**Admin Amendment, site Plan for Building Permit**

RE: 2020-21689, Admin Amendment 6500 Handover Rd NW

**ADMINISTRATIVE AMENDMENT**

Subject: **Supplement to Building Design Considerations for 6500 Hanover Rd NW, Permit No. 2020-21689**

**WEST ELEVATION**

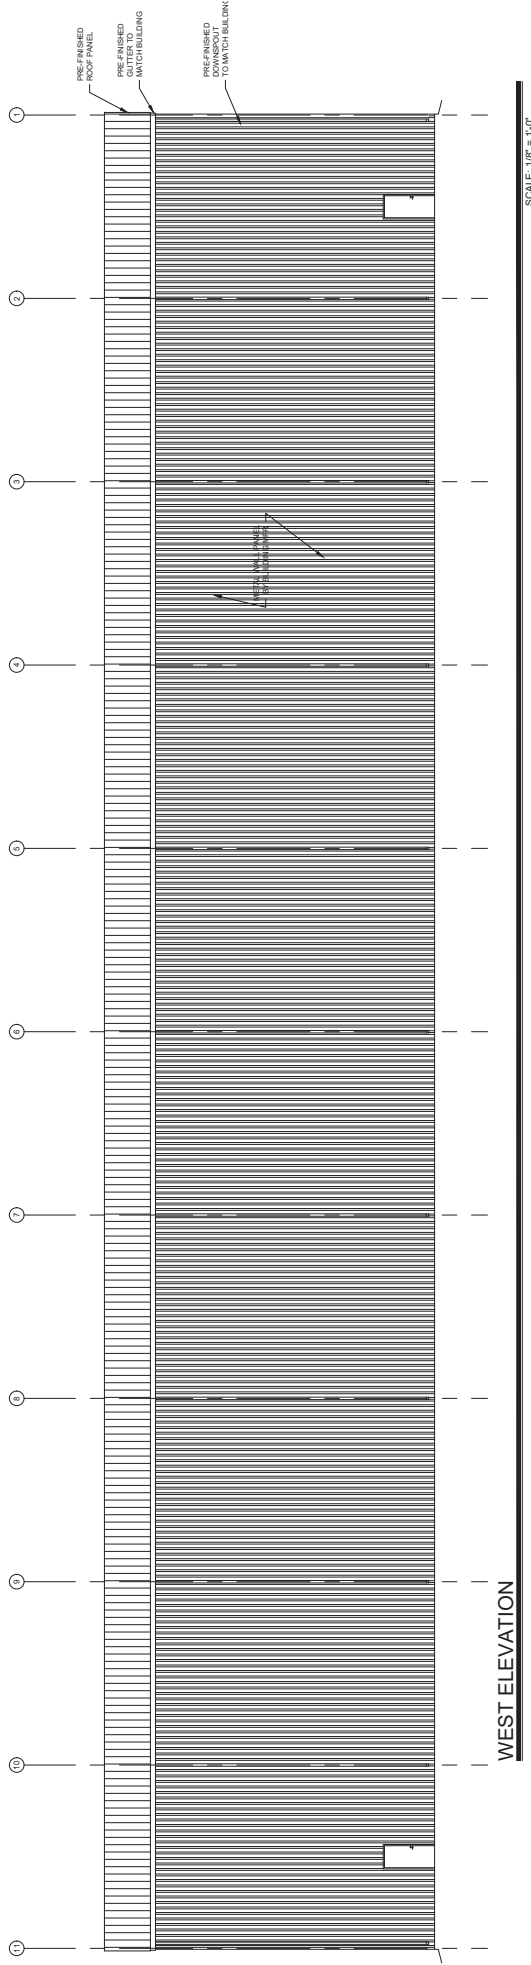
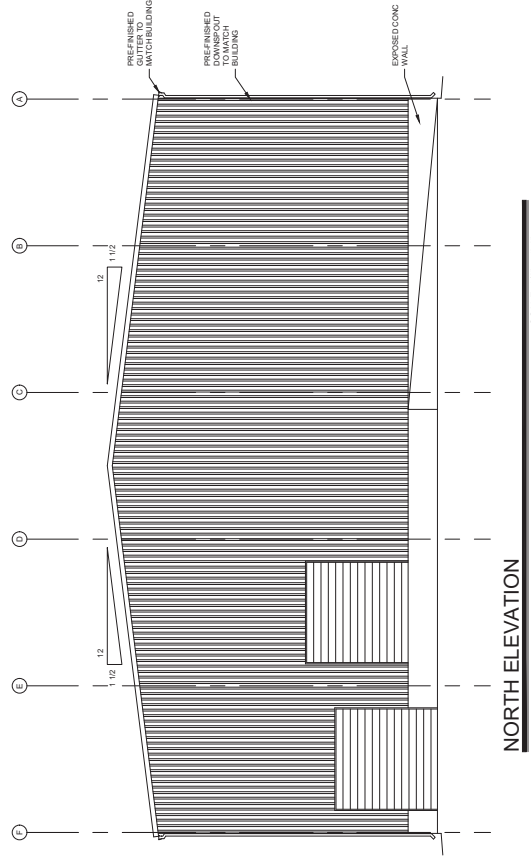
Elimination of all but two of the personnel doors, landscaping, and the curb on the west side of the building.

Addition of overhead doors to the west façade

**SOUTH ELEVATION**

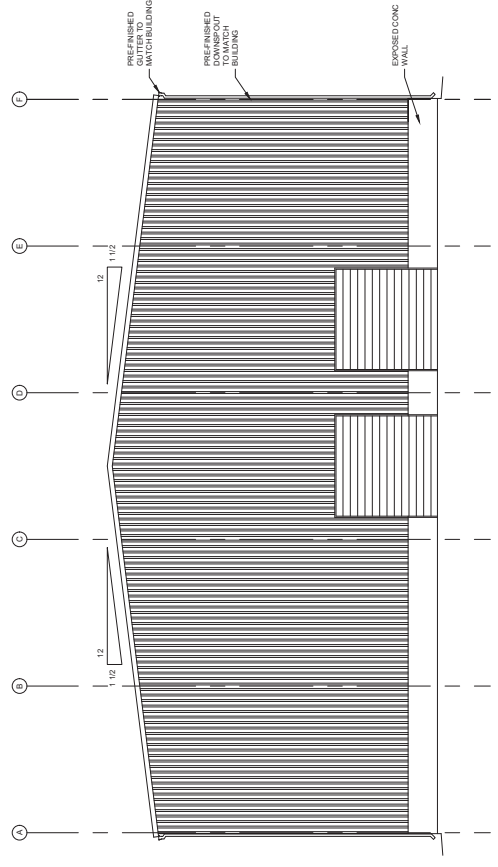
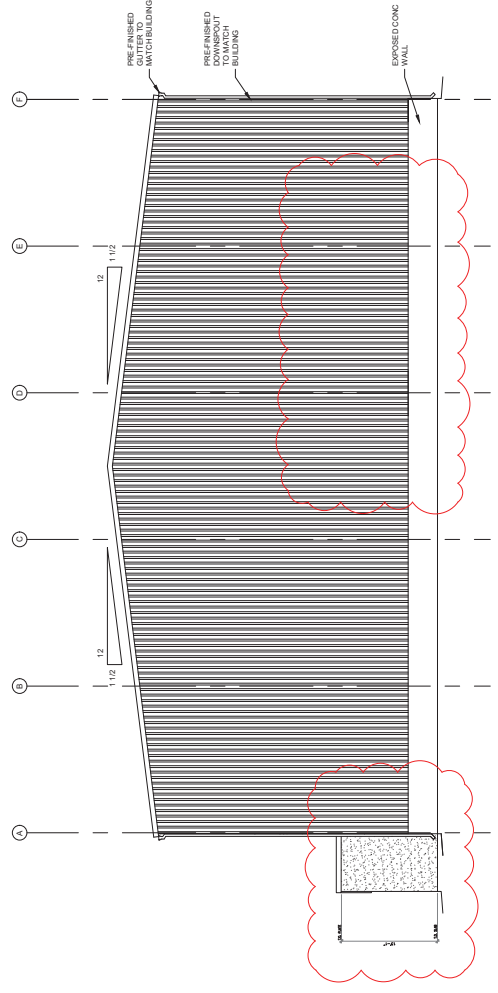
Elimination of the curb and overhead doors on the south side of the building.
